April 26, 2022
Medway Planning & Economic Development Board
Meeting

Public Hearing Continuation
Phytopia – 6 Industrial Park Road
Site Plan, Reduced Parking Special
Permit and Groundwater Protection
Special Permit

**Subject: Response to October 27, 2021 review comments from Tetra Tech
Phytopia, Inc.
Major Site Plan Review
6 Industrial Park Road
Medway, Massachusetts**

**Re: Phytopia Inc.
 Major Site Plan Review
 6 Industrial Park Road
 Medway, Massachusetts**

DRAWING: C6.1
SHEET 7 OF 14

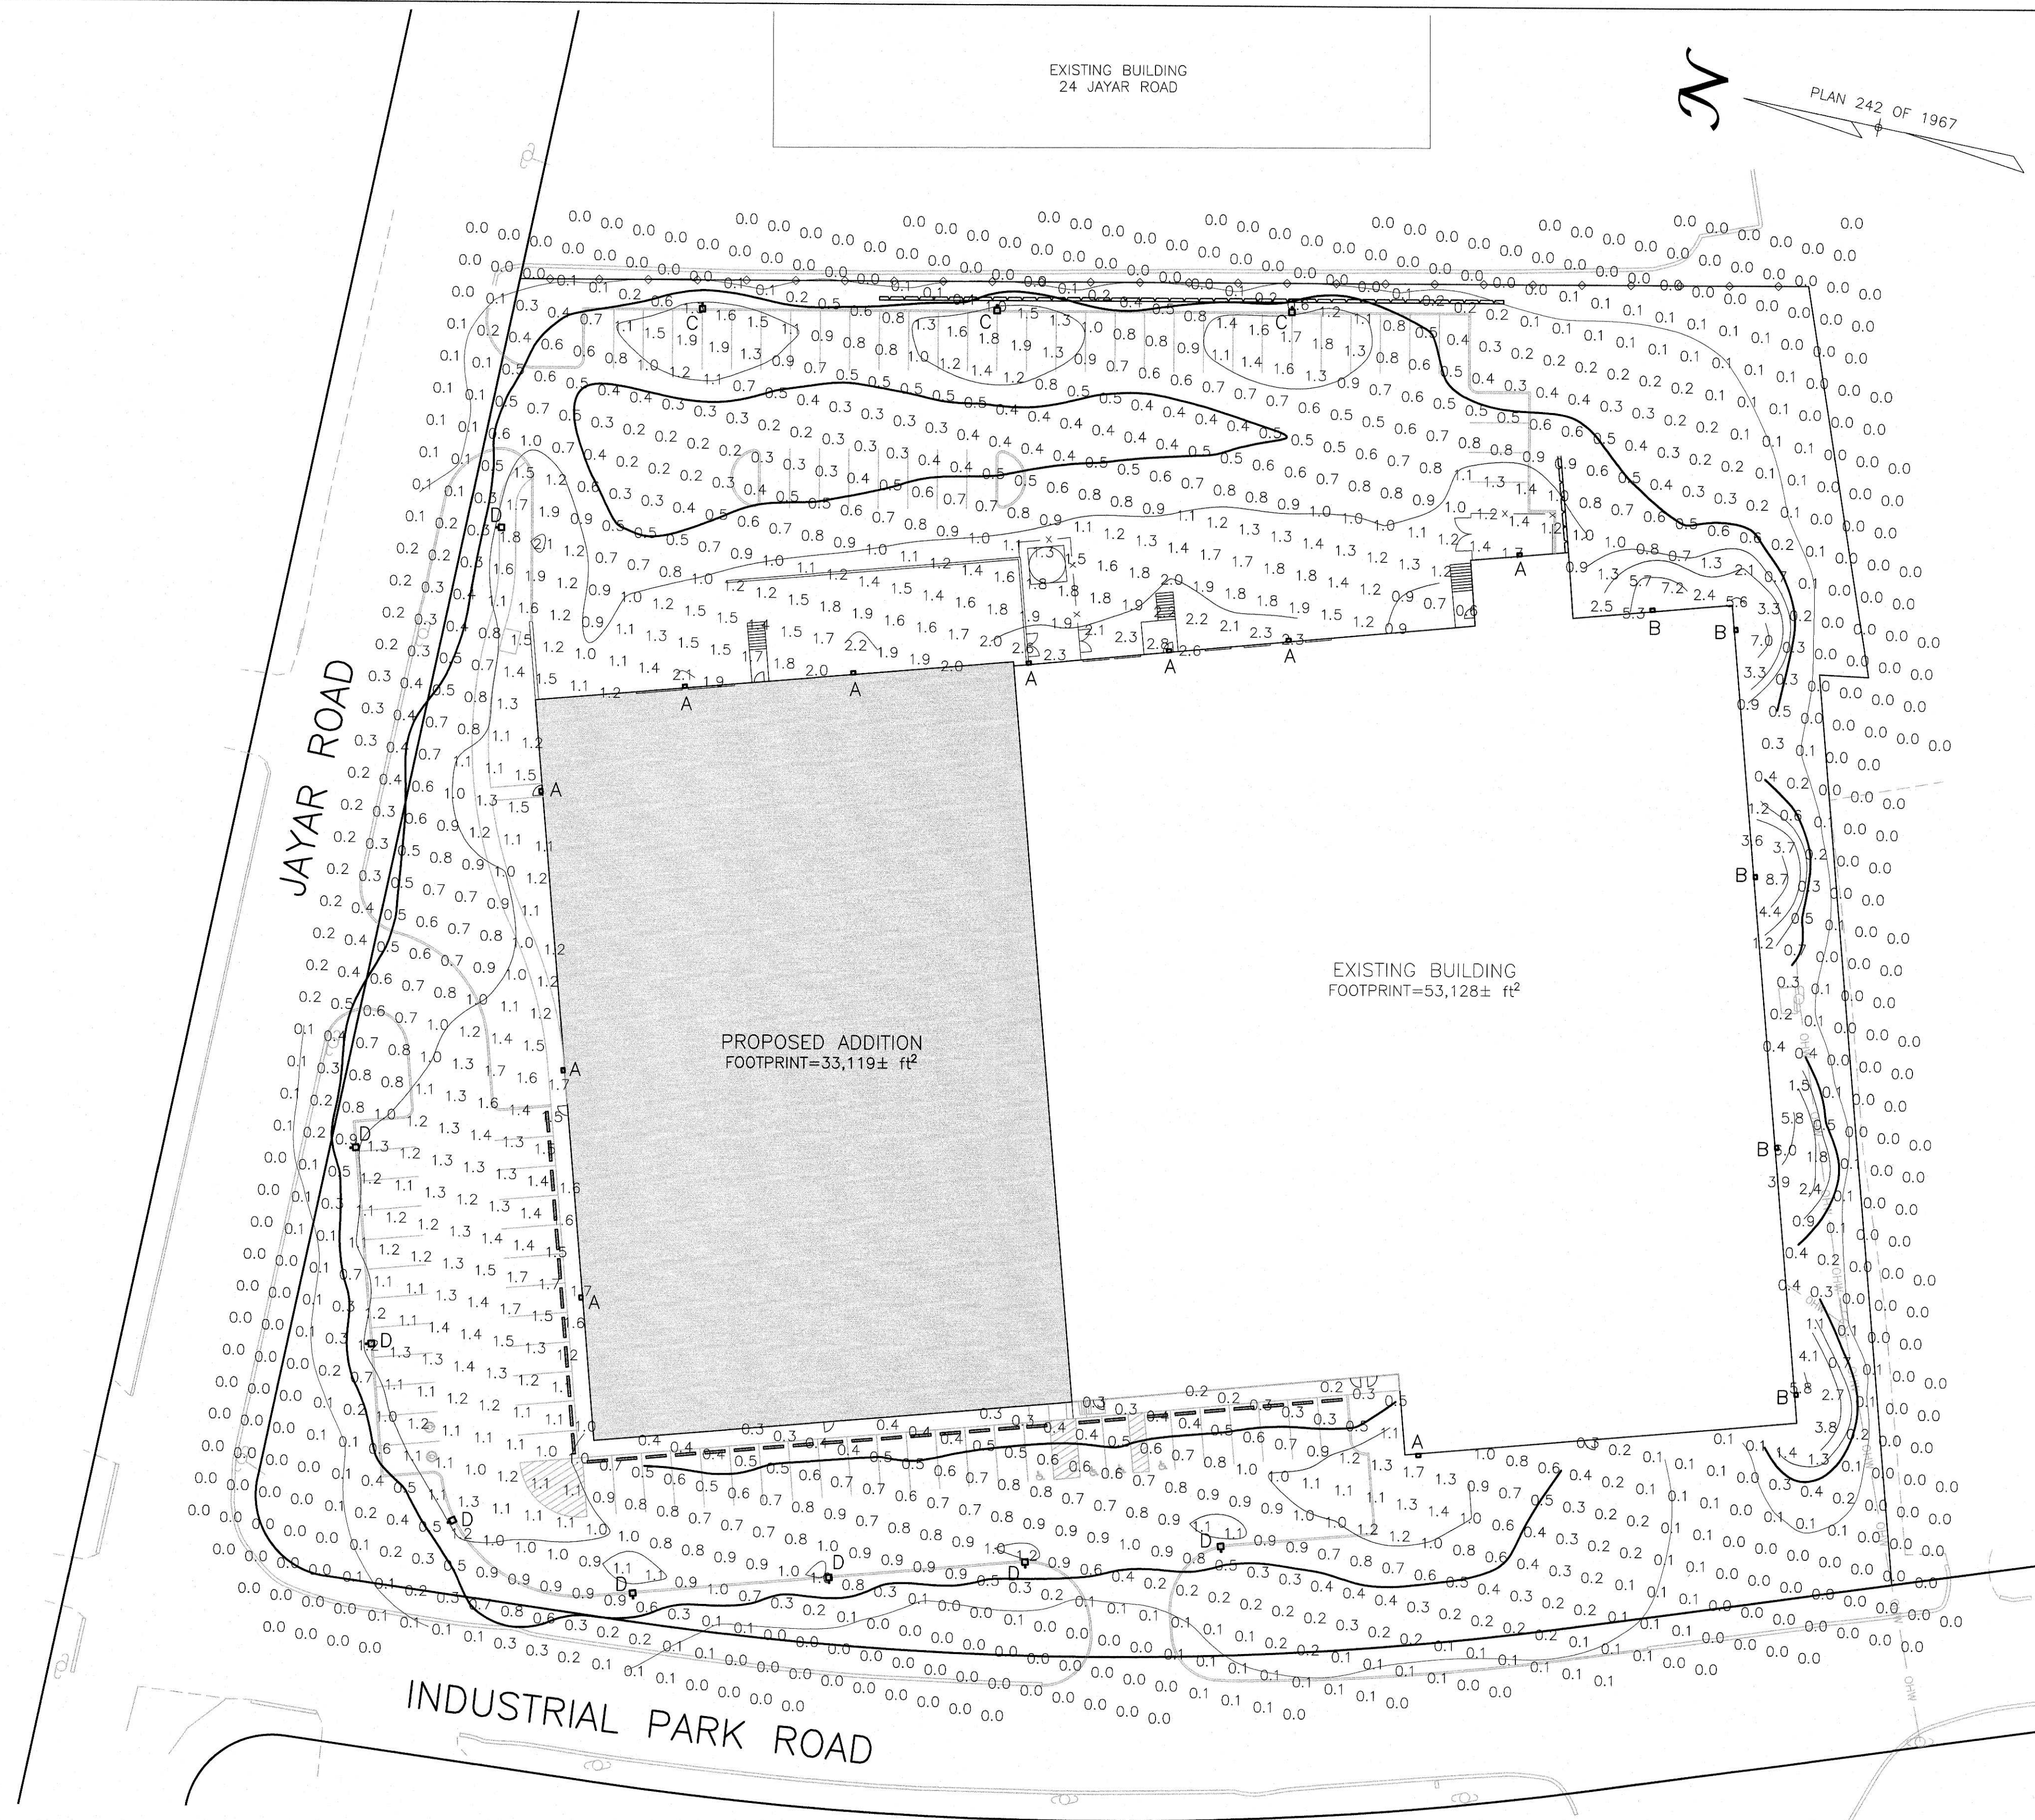
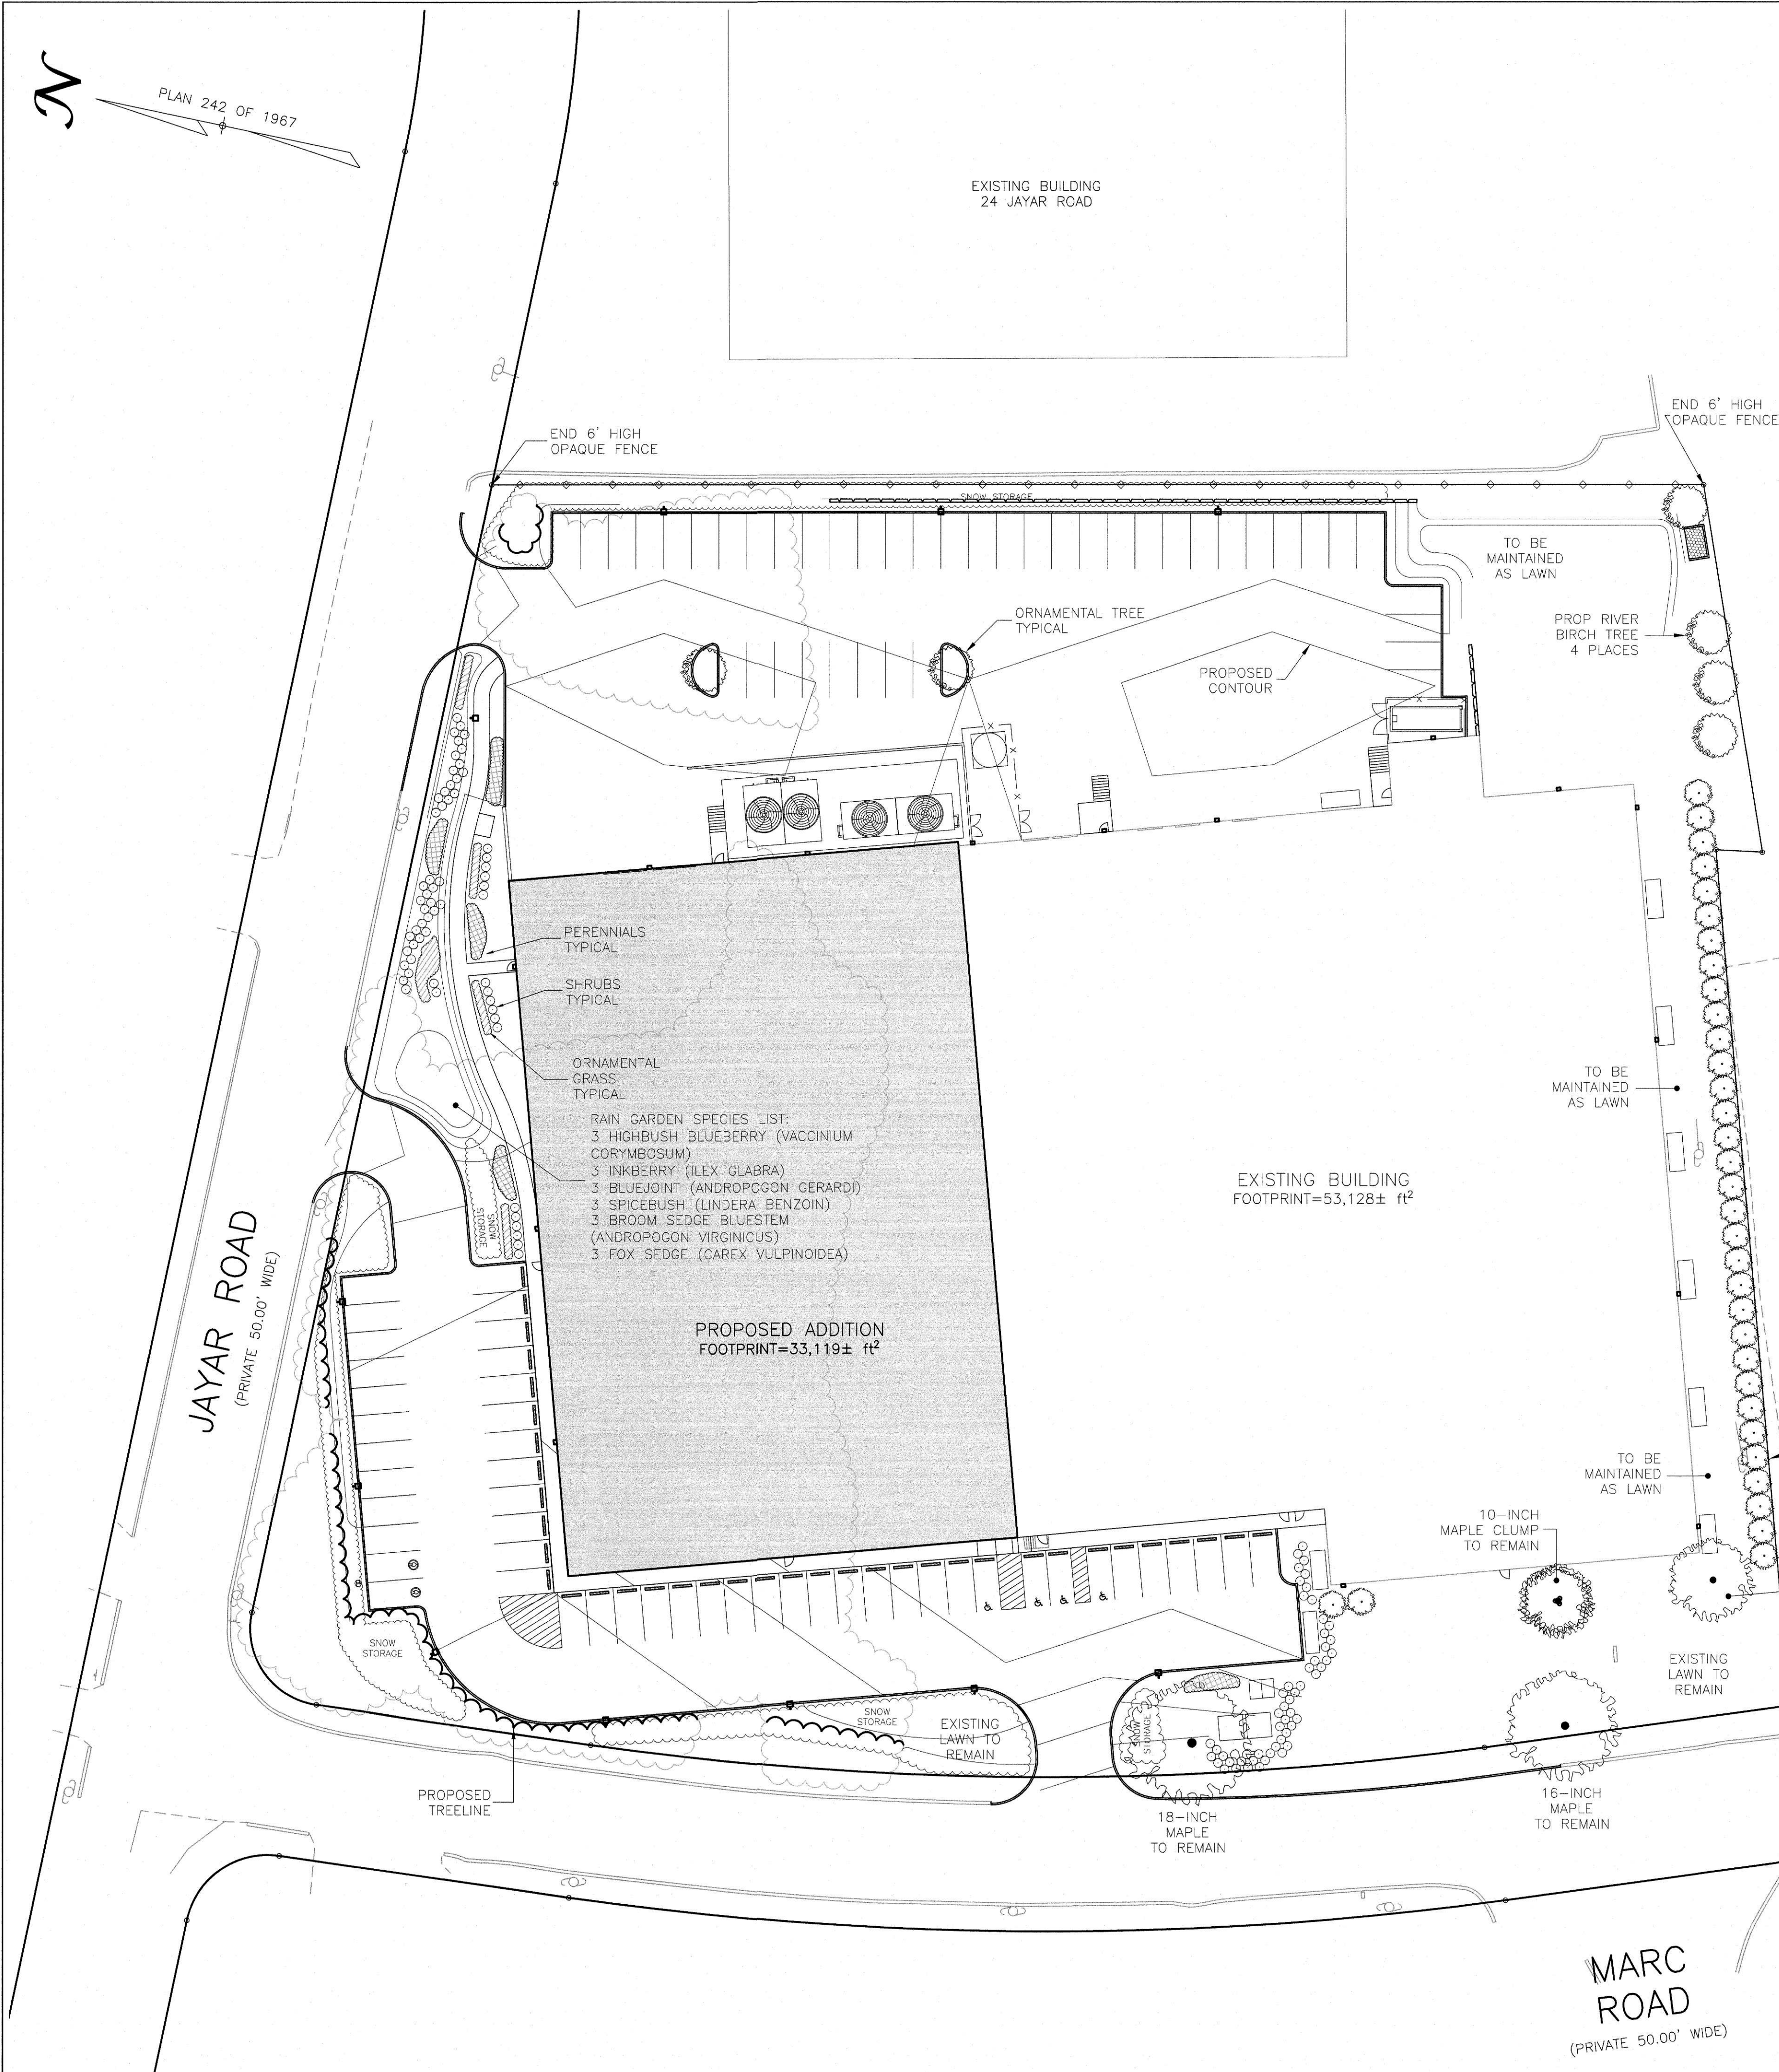
27. The Photometric Plan does not show any light levels beyond the property lines. We anticipate light trespass along the northwestern and northeastern and eastern property lines. (Ch. 200 §207-18)

The Photometric Plan has been revised to show light levels beyond the property line.

The lighting design has been revised to eliminate light trespass on abutting properties. Please see revised Photometric Plan.
